DN22 Service Information.

Line Driver Information.

Line Diver Substitution.

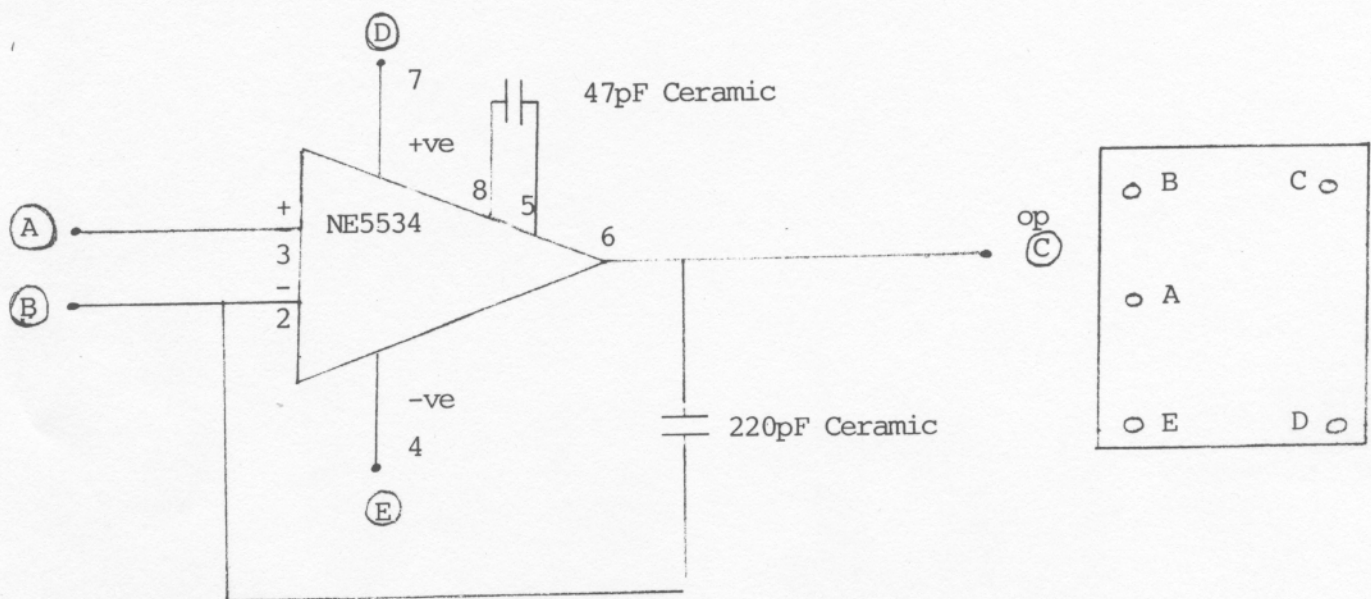
On the schematic diagram for the DN22 the component labelled as LD1 is known as a line driver. This is the output device from the unit and is unfortunately no longer available. This device can be replaced with an NE5534 operational amplifier and two capacitors. The connection details for this modification are shown below. This need only be carried out on failure of the original line driver device.
